Technical Bulletin / Safety Alert

Unique ID No: DES2011-TBSA-08 Rev: 1

Subject: JUG-A-0 UL/UV Diesel Engine System - Inlet Manifolds

Date: 11th February 2014

Figure 3: Photograph showing the additional supporting braces added to the exterior of the inlet manifold for additional support for the flametrap housing.

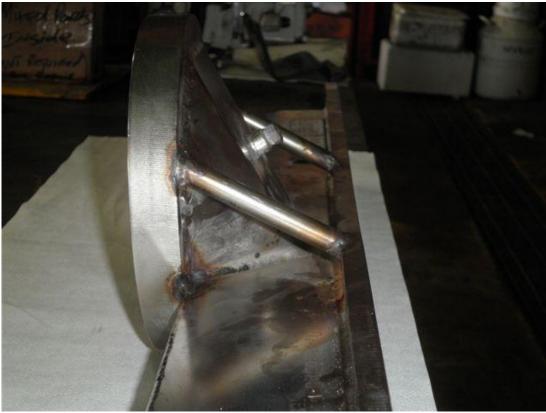
Additional support for the flame trap housings was also suggested via the addition of supporting braces to the exterior of the inlet manifold, as an optional installation.

VLI will now introduce the previously mentioned optional support braces to all new production of inlet manifolds, and recommends installation of these support braces to existing products at the next major service interval, either by modification or exchange.

- 1. Continue to visually inspect all JUG-A-0 air inlet manifolds, conducting soapy water inspections at regular service intervals.
- 2. Ensure correct and secure installation of air intake strangler support bracket (Part No. 0508-60081).
- 3. At the next major service interval, the inlet manifold is to be modified or exchanged to include additional supporting braces.

- 1. All new production of inlet manifolds to be manufactured to the latest design revision, including supporting braces for the inlet flame trap housing.
- 2. All existing stock to be modified to reflect the latest inlet manifold design revision.
